Project: Lincoln Public Schools – Irving Middle School Indoor Air Quality Improvements
Irving Middle School
2745 S. 22nd Street, Lincoln, NE 68502

Bid Pckg: #7922

Project No.: Engineers Project No.: 2014-070

ADDENDUM #1

11.3B

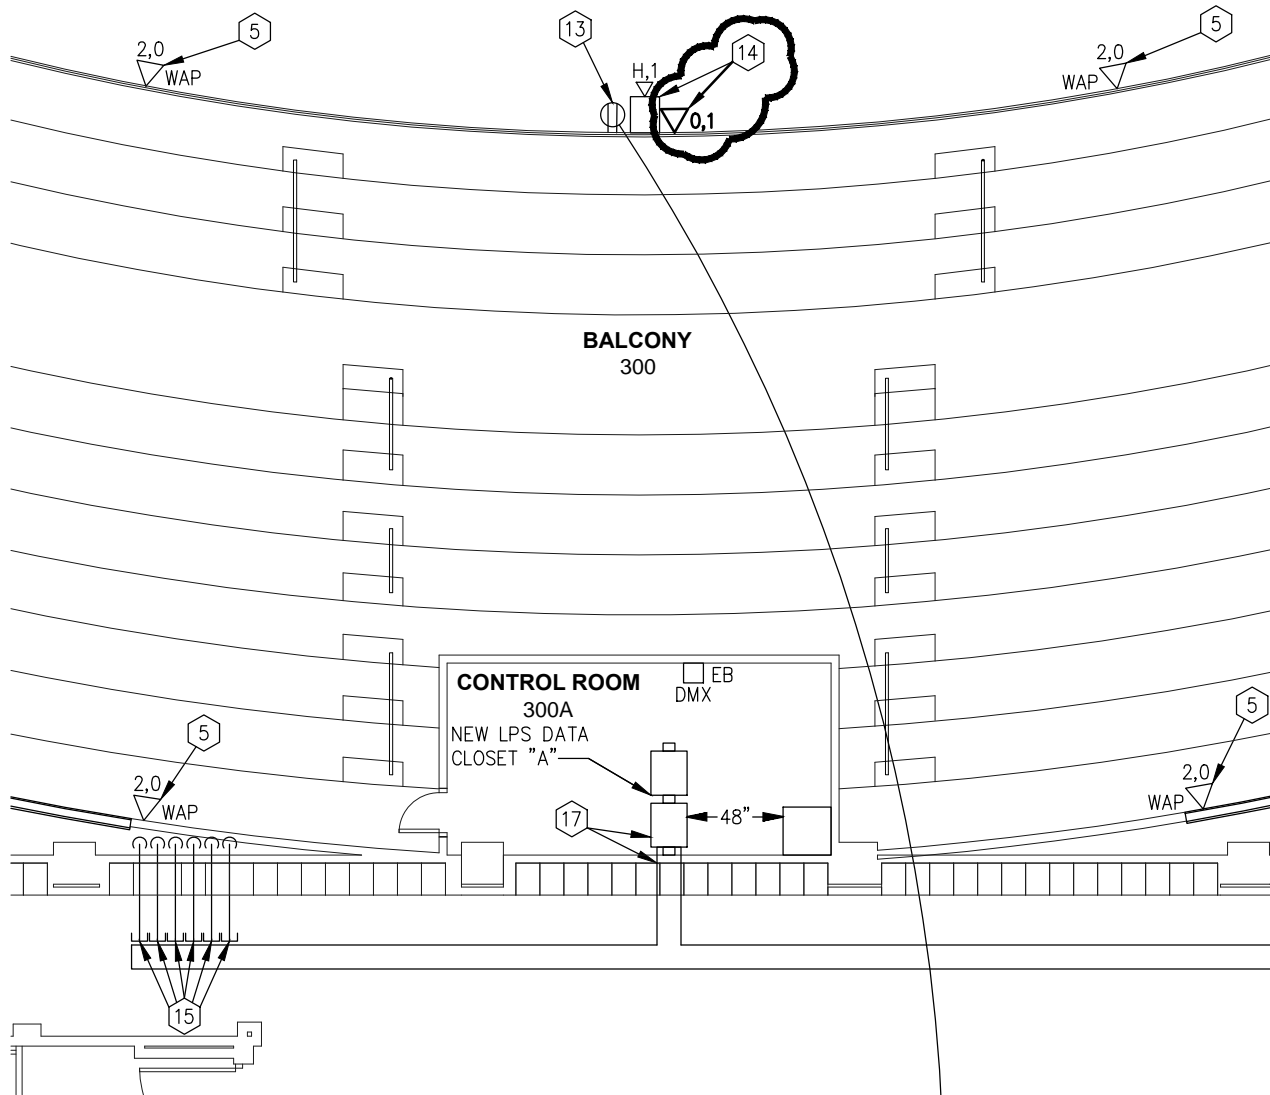
- E. Sheet T1.3B Third Floor Plan – Area B – Telecommunications
 - i. Attachment #1 – See attached drawing for revision.
 - ii. Attachment #2 – See attached drawing for revision.

14. PROJECTOR LOCATION. COORDINATE EXACT LOCATION IN FIELD TO ALLOW FOR CONTINUED USE OF EXISTING CLOCK. ROUTE HDMI CABLE IN 2" CONDUIT TO NEW CONTROL BOOTH. PROVIDE DATA OUTLET LOCATION FOR PROJECTOR. ROUTE ONE CAT-6 CABLE FROM DATA CLOSET TO DATA OUTLET. REFER TO SHEET T0.0 FOR DATA CLOSET LOCATION. PROVIDE WIREMOLD BOX AND WIREMOLD AS NECESSARY. REFER TO DETAIL 1 ON SHEET TC1.5 FOR AND SHEET T1.2B FOR ADDITIONAL INFORMATION.
